CITY PLAN COMMISSION

FILE NUMBER: S234-092 SENIOR PLANNER: Sharmila Shrestha

REQUEST: An application to replat a 10.7077-acre tract of land containing all of Lots 1 and 2 in City Block A/8703 to create one lot on property located on South Ledbetter Drive, south of Illinois Avenue.

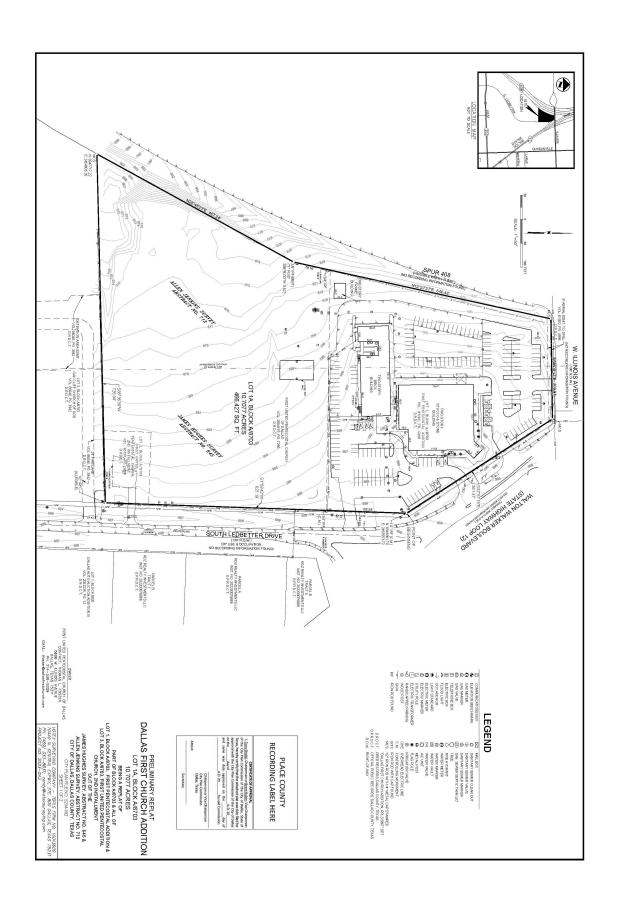
- 15. On the final plat, dedicate 50 feet of right-of-way (via fee simple) from the established center line of Illinois Avenue. Section 51A 8.602(c)
- 16. On the final plat, dedicate 30 feet of right-of-way (via fee simple) from the established center line of South Ledbetter Drive. Section 51A 8.602(c)

- 17. On the final plat, dedicate 53.5 feet of right-of-way (via fee simple) from the established center line of Walton Waker Boulevard. Section 51A 8.602(c)

- 18. On the final plat, dedicate a minimum 25-foot by 25-foot corner clip (via fee simple or street easement) at the intersection of Illinois Avenue and South Ledbetter Drive. Section 51A 8.602(d)(1)

- 19. On the final plat, dedicate a minimum 25-foot by 25-foot corner clip (via fee simple or street easement) at the intersection of Illinois Avenue and State Highway Spur No. 408. Section 51A 8.602(d)(1)

- 31. On the final plat, change "Spur 408" to "State Highway Spur No. 408".
- 32. On the final plat, change "Walton Walker Boulevard (State Highway Loop 12)" to "Walton Walker Boulevard/ State Highway No. 12".
- 33. On the final plat, change "South Ledbetter Drive" to "South Ledbetter Drive (FKA Kessler Outer Boulevard)".
- 34. On the final plat, change "W. Illinois Avenue" to "Illinois Avenue".
- 35. On the final plat, identify the property as Lot 1A in City Block A/8703.
